Petitions – Stop the Coundon Cycleway, and Support the Coundon Cycleway

APPENDIX A - SCHEME DETAILS

These drawings are Post-Consultation.
The notes on the plans highlight the changes
made from the consultation drawings.

Project: Air Quality Action Plan
Coundon Cycleway

Title: General Layout
Sheet 1 of 17

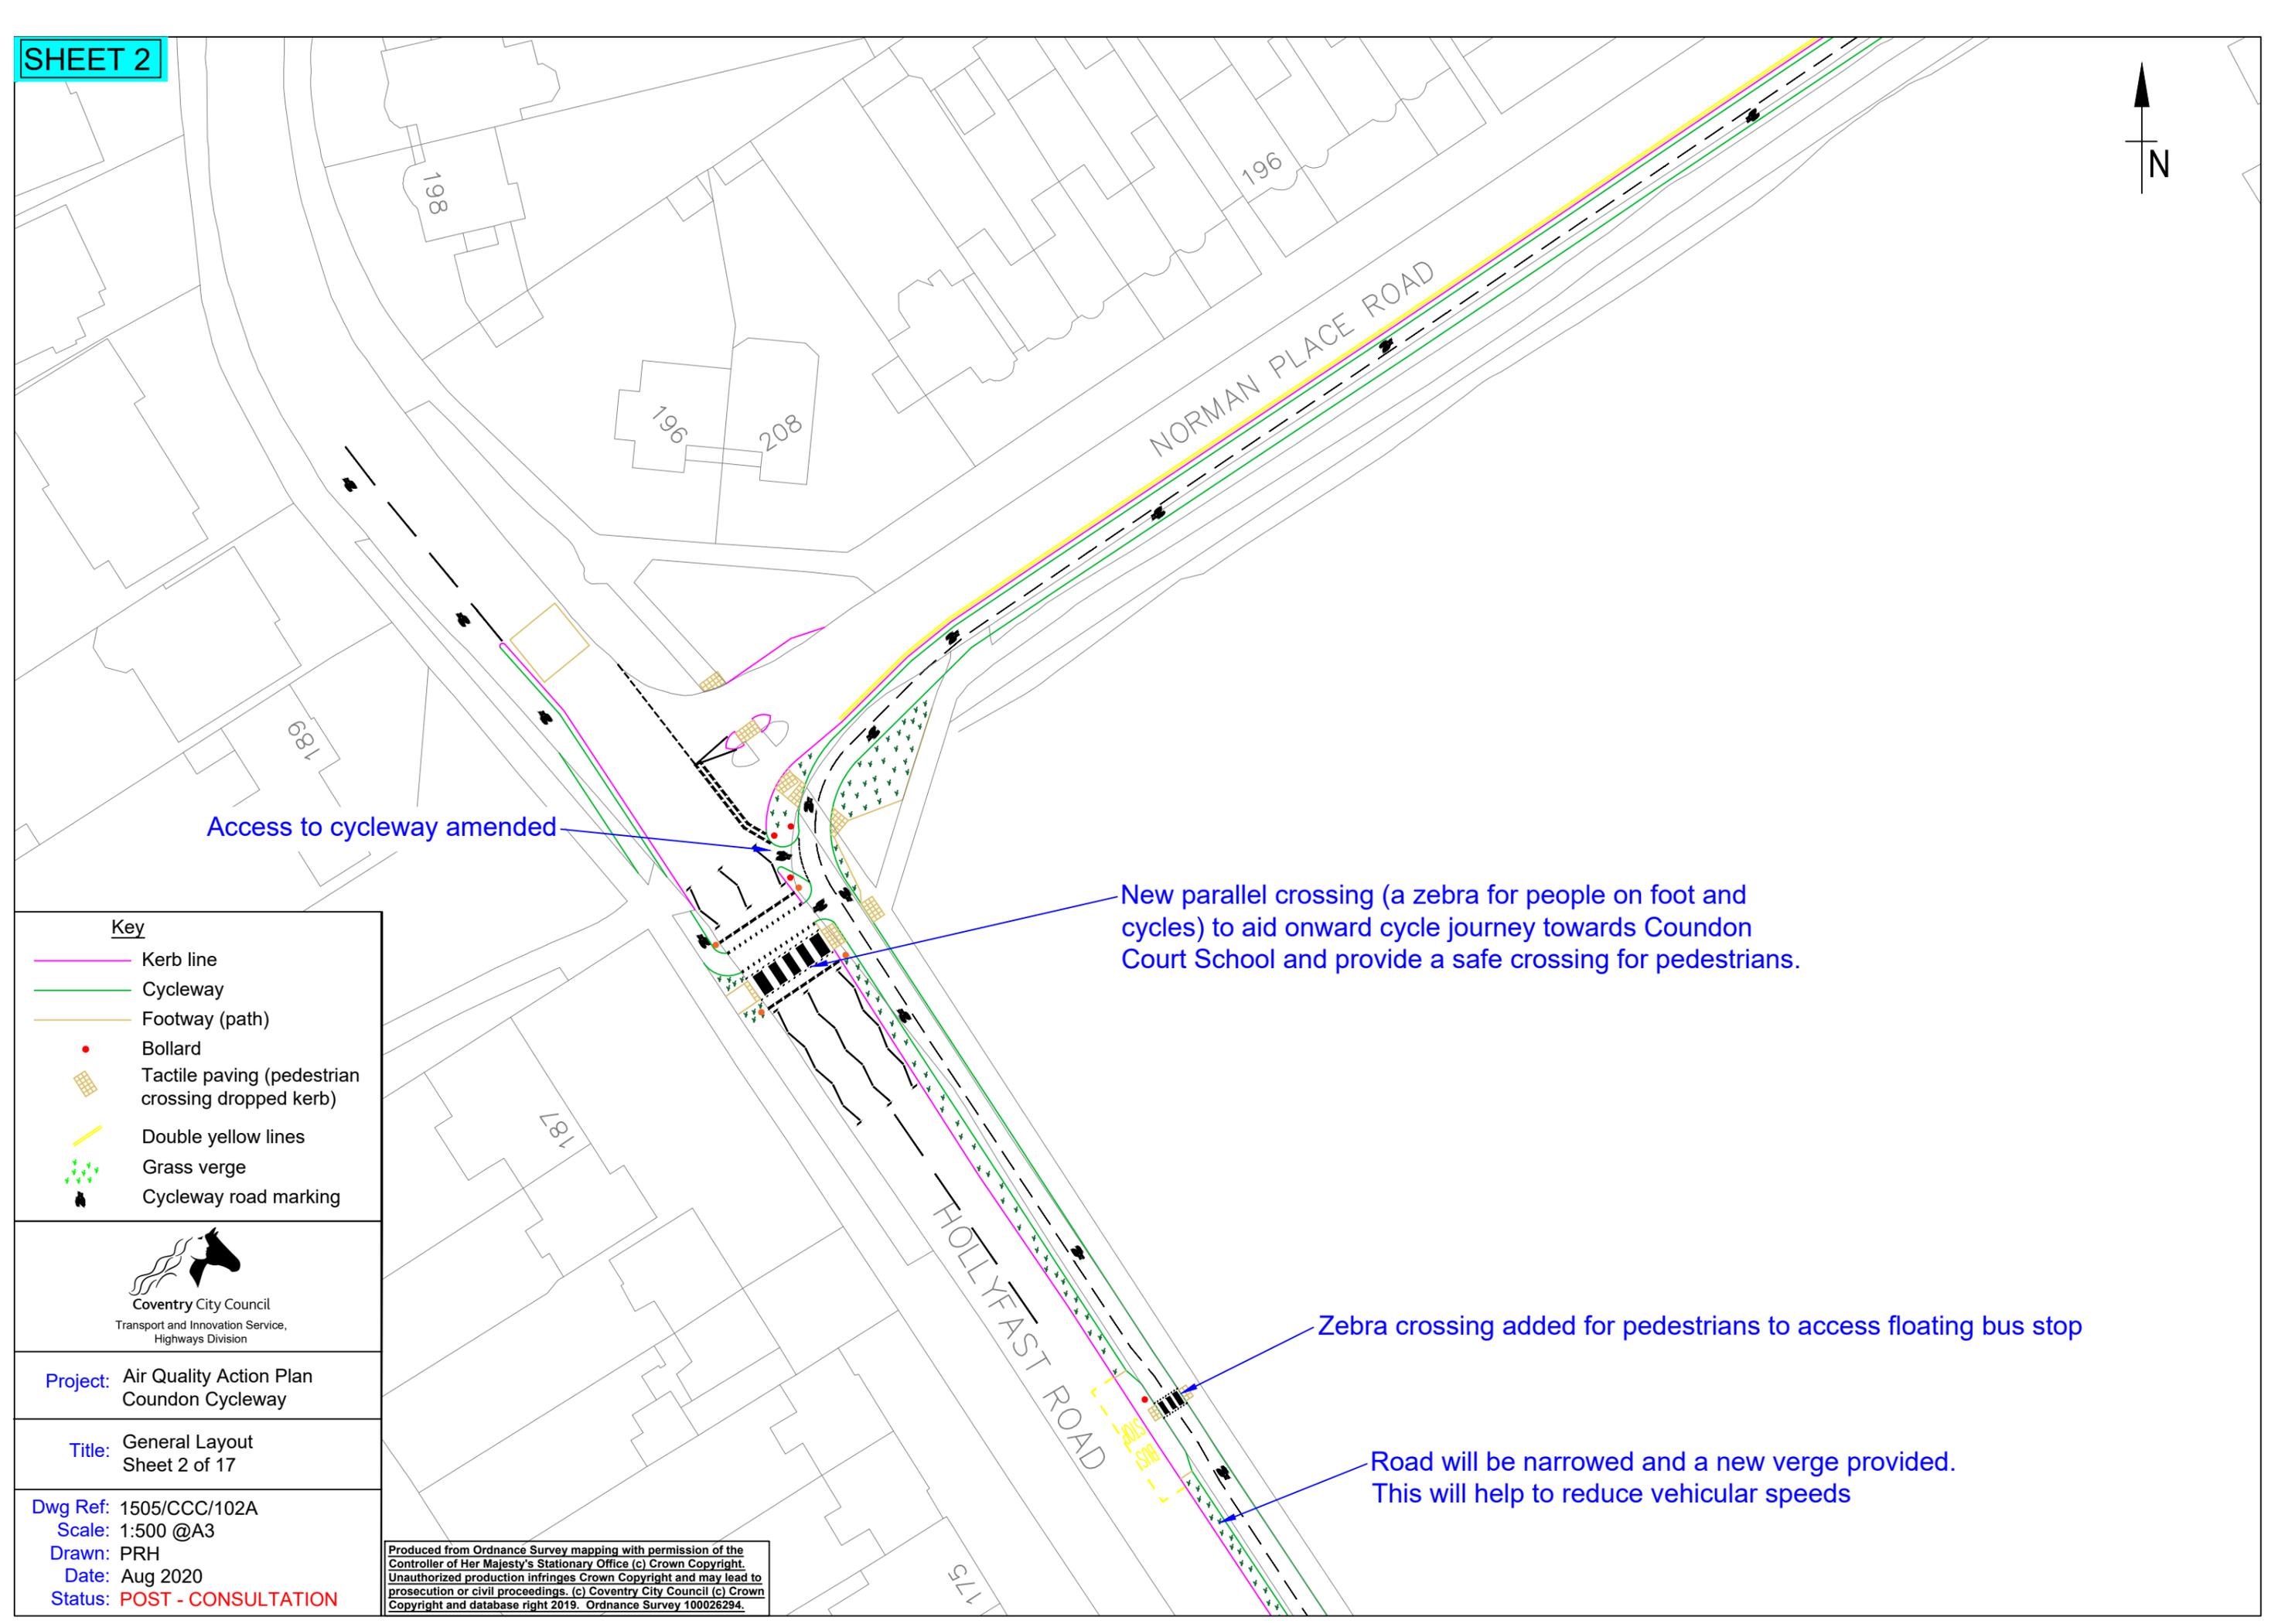
A splitter island will be added to offer protection for people on cycles joining from Birchfield Road

kerbed build out to enable safer crossing of road

Layout changed to create a mini one-way system. This serves Duncroft Ave, Bablake Playing Fields and bus traffic. Pedestrians route improved along Norman Place Road with no road crossings now required.

Cycleway created in place of existing hard verge

Traffic gives way to cycleway and footway. Vehicles go a ramp to cross the footway.

Zebra crossing added for pedestrians to access floating bus stop

Title: General Layout
Sheet 3 of 17

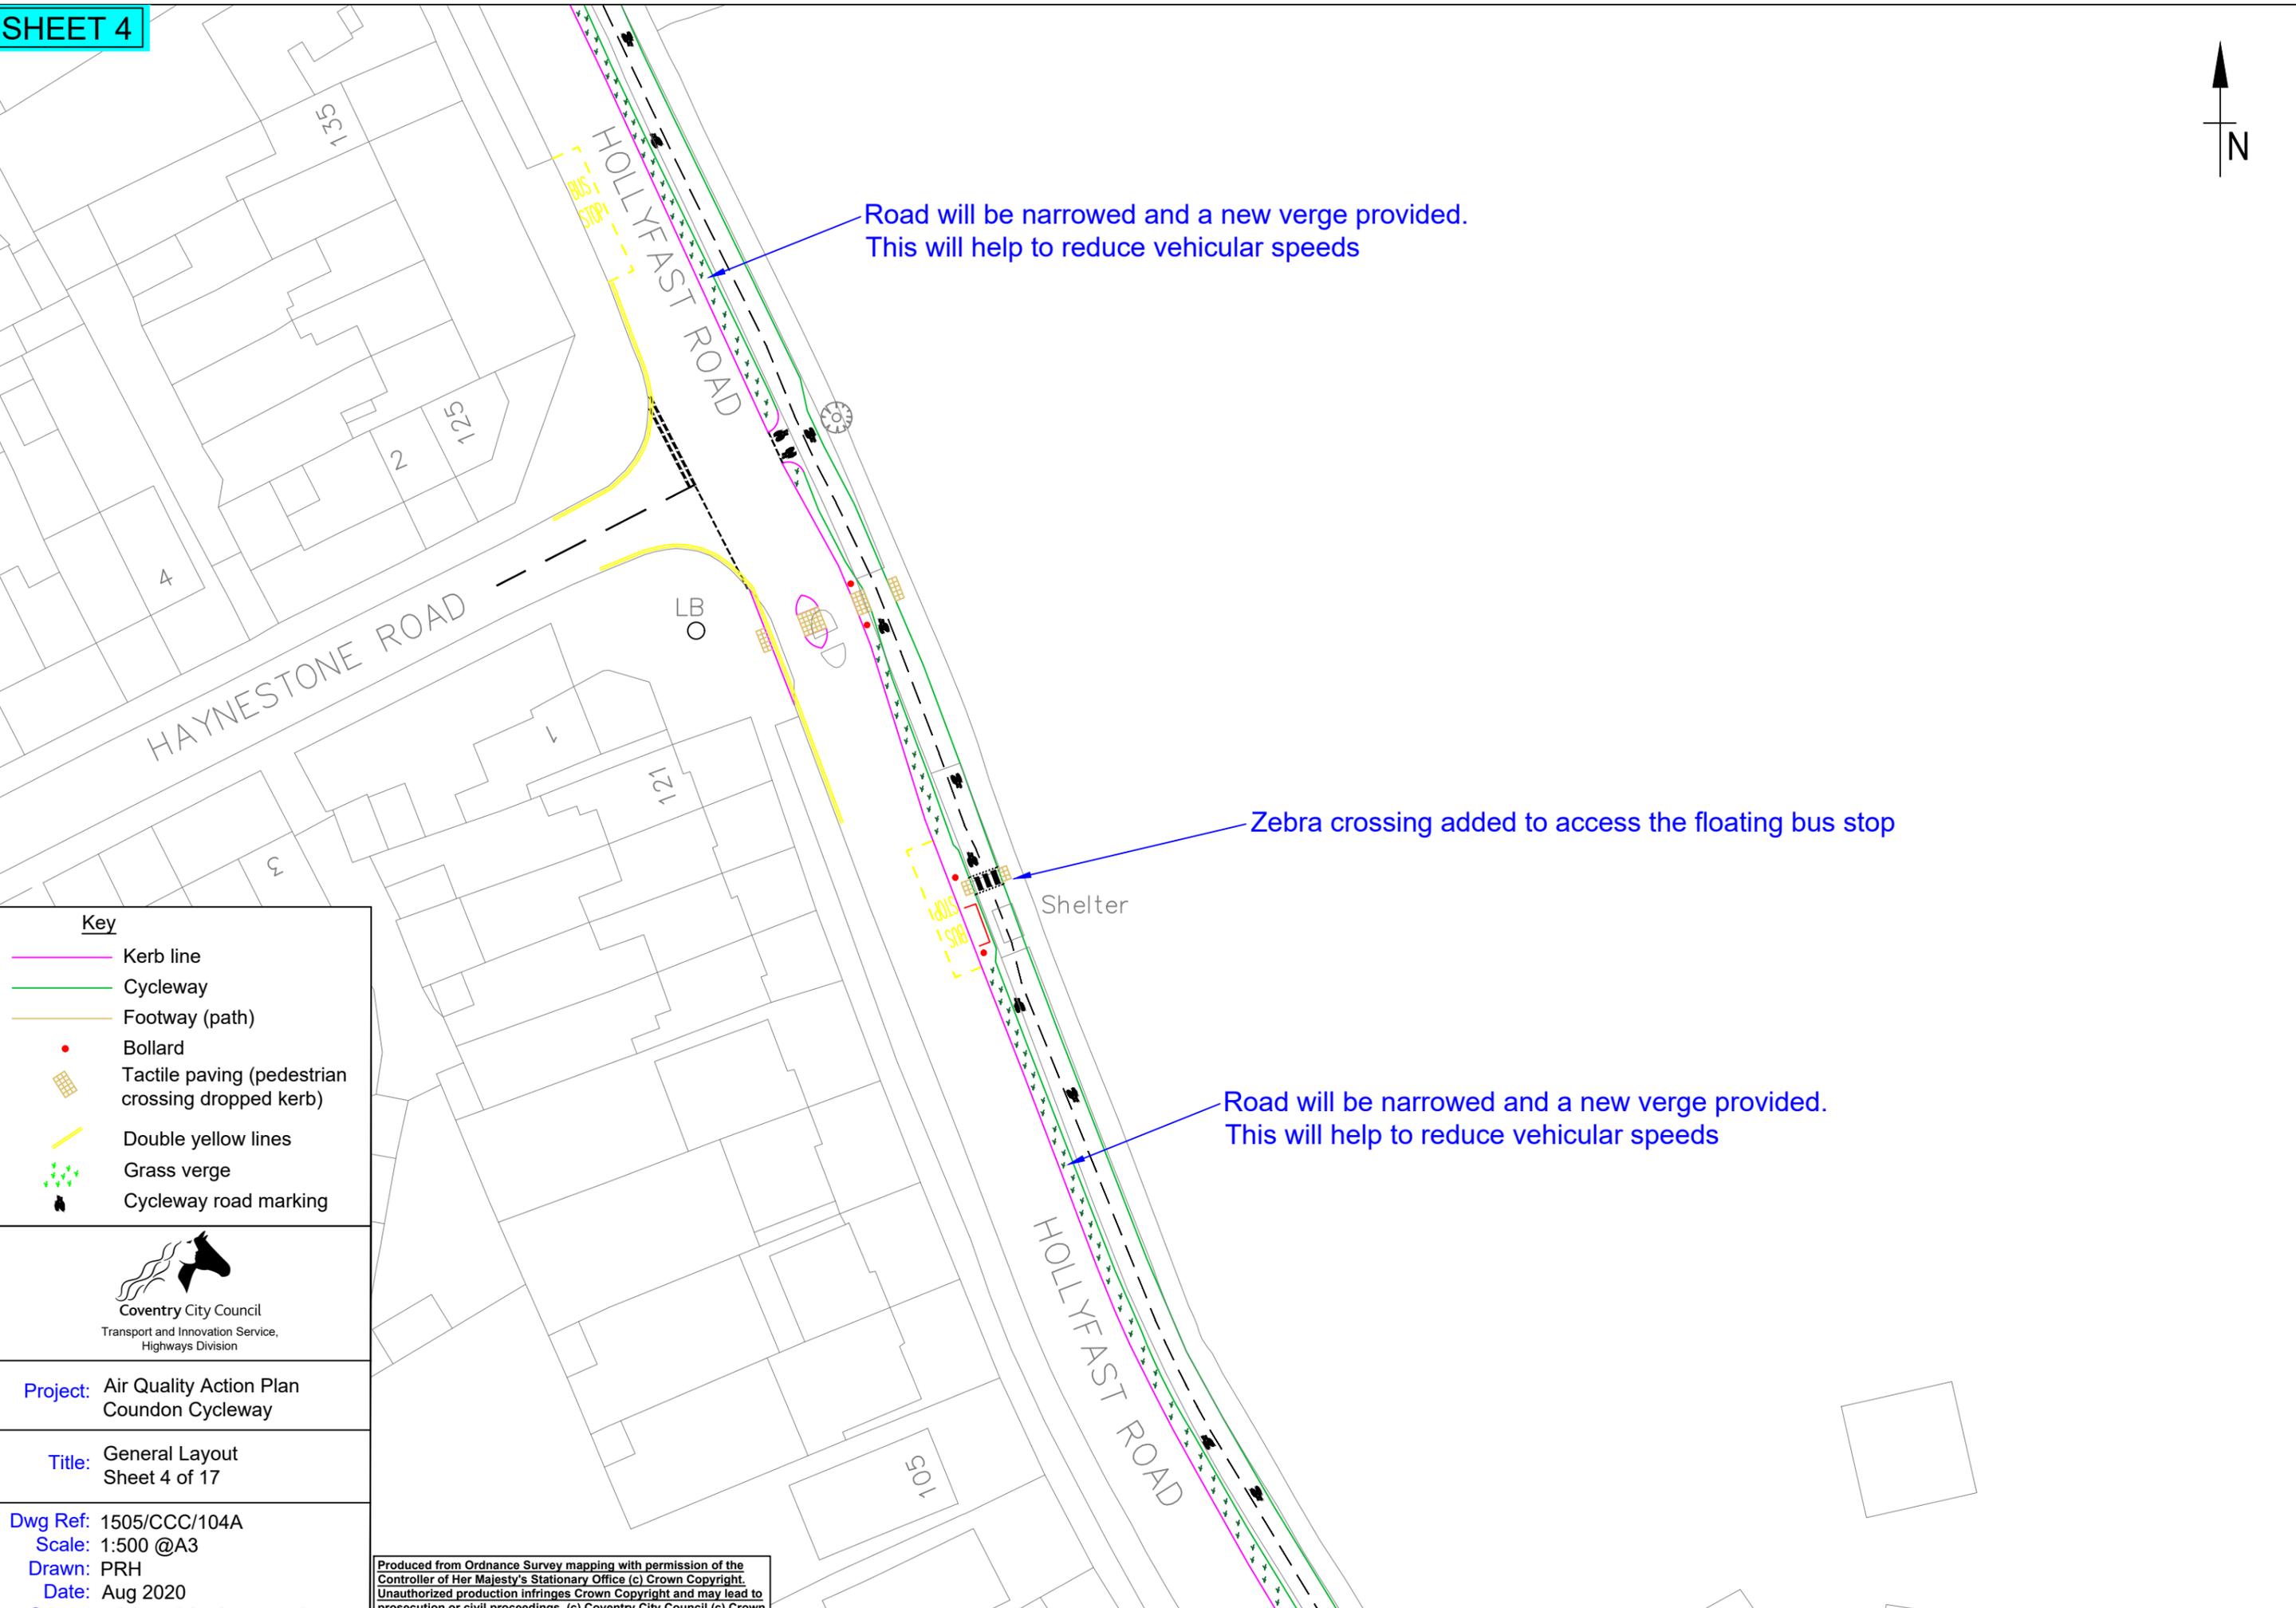
Cross Section. See inset

Road will be narrowed and a new verge provided. This will help to reduce vehicular speeds and maintain a green corridor

Road will be narrowed and a new verge provided.
This will help to reduce vehicular speeds

Zebra crossing added to access the floating bus stop

Road will be narrowed and a new verge provided.
This will help to reduce vehicular speeds

Title: General Layout
Sheet 5 of 17

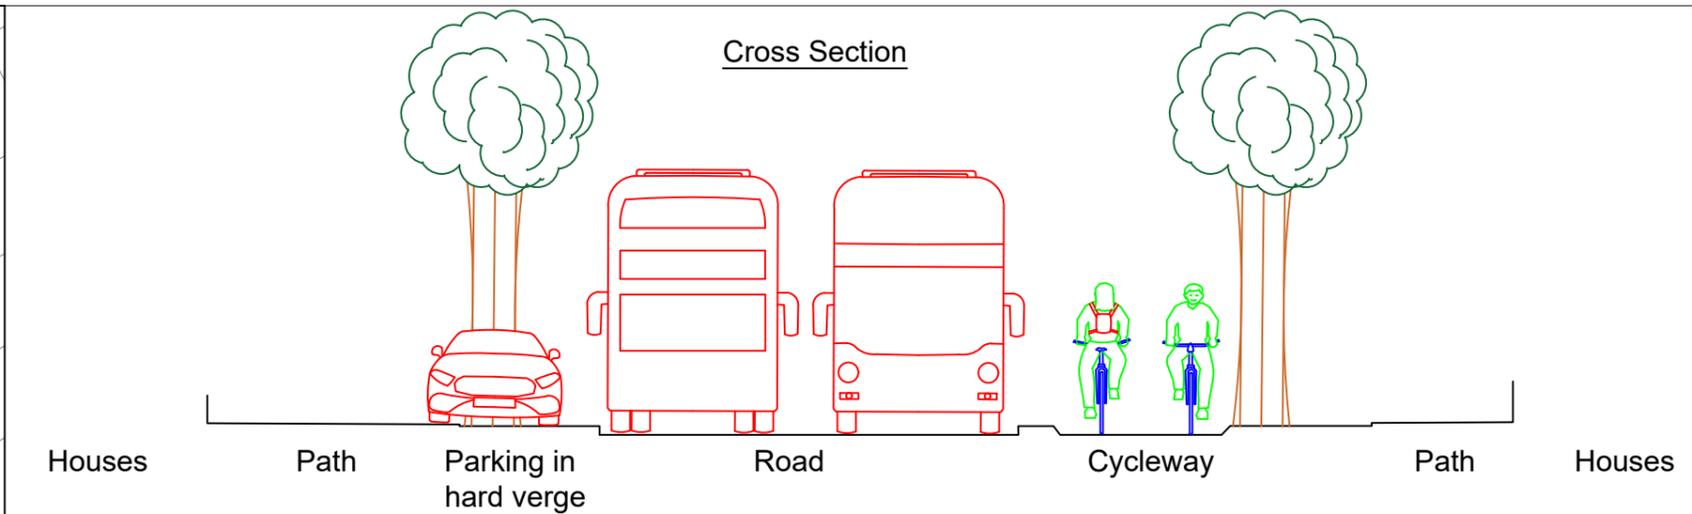
The window for parking restrictions on the carriageway will be further reviewed and subject to Traffic Regulation Order consultation.

Access and parking arrangements for 46-54 Westhill Road are being further reviewed and are subject to additional consultation

New kerbing and a buffer zone to be installed to improve safety of cycleway users

Informal layby on carriageway to be provided to accommodate wedding and funeral vehicles. Cycleway will also be at same level as footway at this section to ensure ease of access to church
